Agenda Item # 12

SUB-002850-2024 & ZON-UDC-002851-2024

Striker’s Club, Inc. Subdivision

APPLICATION NUMBER <u> 12 </u> DATE <u> March 21, 2024 </u>	 NTS
APPLICANT <u> Striker's Club, Inc. Subdivision </u>	
REQUEST <u> Subdivision, Rezoning from R-2, B-1, and B-3 to B-3 </u>

SITE PLAN

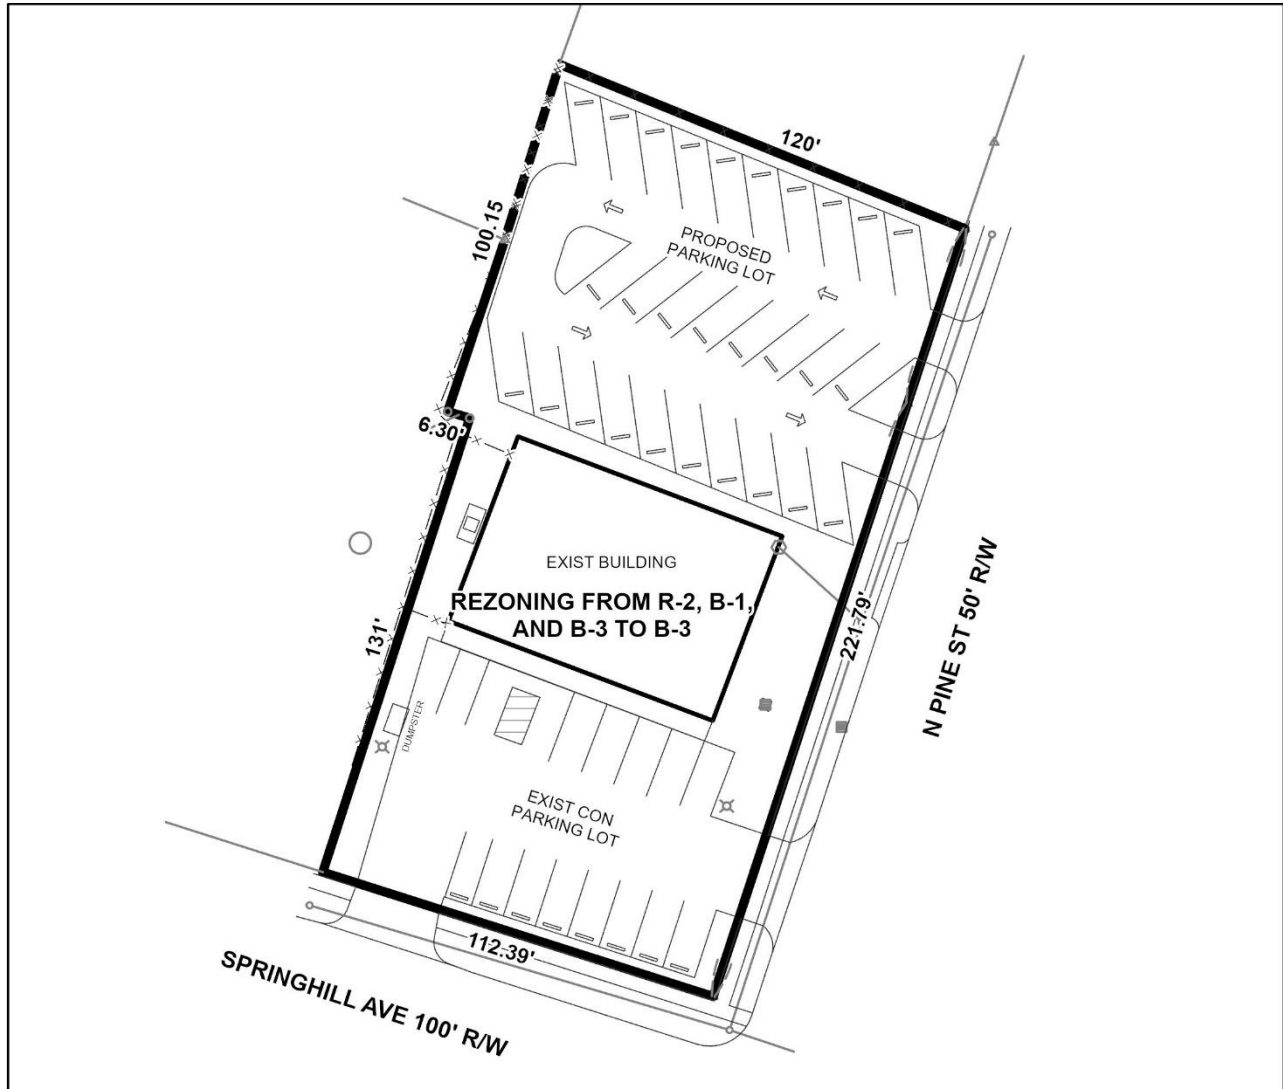
The conceptual plan submitted with the request illustrates that additional parking will be constructed on a portion of the proposed lot and will serve the existing commercial building. Bringing the site under one (1) zoning classification, particularly a commercial classification, is necessary to facilitate further development of the site.

A privacy fence is illustrated on the conceptual plan where the site adjoins residential property; however, if approved, full compliance with the Protection Buffer requirements of Article 3, Section 64-3-8 of the UDC will be required, including a 10-foot setback and the provision of a vegetative screen planting strip. Such compliance should be illustrated on any site plan submitted for the review and approval of development permits.
